Thanet Extension Offshore Wind Farm

Appendix 4 to Deadline 2 Submission: Applicant's Response to Written Representation - Pilotage

Date: February 2019

Revision A

Figure 1: NE Spit Sea Room Distances (Appendix 25 Annex B)

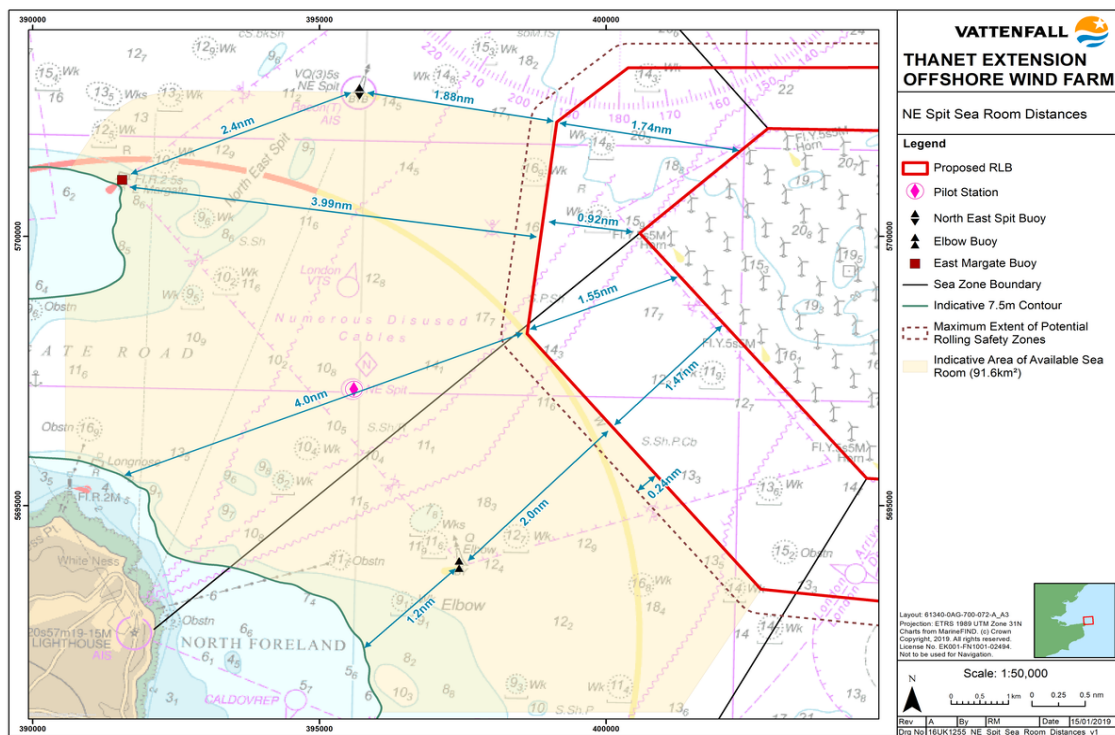
- 10 The Applicant notes that within the WRs issued by ESL and PLA (para 5.7 of REP1-141 and para 5.7 of REP1-142 respectively) a key concern raised is the reduction in sea room around the NE Spit pilot station, specifically that the available space between the closest point of the array and the NE Spit pilot station would be reduced to 1.7 miles: “5.7 A key concern of ESL is the reduction in sea room. The closest point of the extended wind farm to the NE Spit pilot station would be 1.7 miles (leaving approximately 2.1nm to the most eastern extent of the Margate Roads anchorage). At this point there is a lot of crossover traffic which needs to be taken into account”. This is also noted in the WR from Port of Tilbury and London Gateway (section 4, bullet 2, REP1-148) and LPC who reference this area.

- 11 The Applicant notes, as per the sea room plot provided at Annex B, that the width at the narrowest point is 1.88nm (between the NE Spit buoy and the red line boundary) and greater area of sea room exists to the south (see Figure 1). The area to the south, in the vicinity of the NE Spit pilot boarding station, is where pilot transfers are undertaken (see Figure 2 taken from Figure 48 of Annex 10-1 Application Ref 6.4.10.1) and as such noting the sea room plot at Annex B, there remains sufficient sea room within the NE Spit pilot boarding area post construction of the TEOW for pilot boarding.

Figure 5 Turning Circles for vessel length 236m and 299m LOA

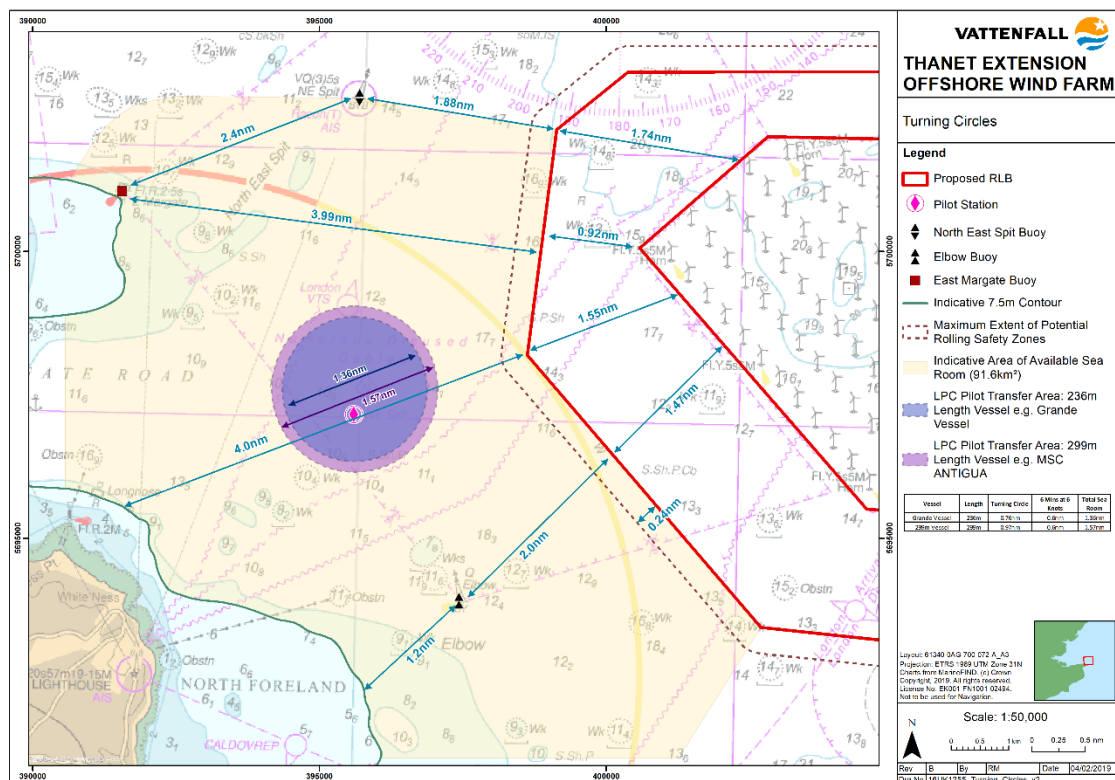
- 22 LPC have supplemented their submission with assessing the required sea room for pilot transfers using some of the guidance from MGN543 (Section 10.3, MGN Compliance at pg 6 of the LPC Action Point document, REP1-104), providing sea room calculations for a range of vessel sizes as provided in the table at Figure 2.

- 25 LPC have noted that the 'required safe room' consists of a turning circle of 6 x LOA (as per MGN543) plus a margin for pilot boarding time of 6 minutes at 6 knots (0.6nm distance), which is consistent with the grading criteria in the bridge navigation simulation undertaken by the Applicant with PLA and ESL as evidenced by comparison of simulated vessel tracks with the LPC calculations (see below).
- 26 The turning circle for a vessel a 299m LOA vessel is 1.57nm, and for a Grande class vessel with a length of 236m, which was used as a representative vessel in the Pilotage Bridge Simulations it was 1.4nm. In order to provide indicative context of the sea room, the Applicant has transposed these pilot boarding areas of 'required safe room' onto the sea room plot to show that for the vessels identified there is adequate sea room for these transfers (see Figure 5).

- 28 The sea room required for pilot boarding has been specified in the LPC Fig 2 table in their WR with reference to MGN543 Annex 3 which is calculated based on vessel length and a pilot boarding time element. The Applicant considers these to be reasonable representation of the sea room required as presented by the practitioners, which are consistent with the Applicant's assessments from the Pilotage Simulation Study, the Pilotage Study and by reference to vessel tracks collected as part of the Vessel Traffic Survey (see Figure 6). As such LDC have specified the need to maintain a course for a period of 6 minutes at an approximate speed of 6 knots, which gives a total track of a pilot launch being alongside a vessel of around 0.6nm, which, as has shown above, is available, with a 0.5nm safety buffer, and further available sea room (the circles do not take up all space for pilot boarding in Figure 5 post construction of the TEOWF).
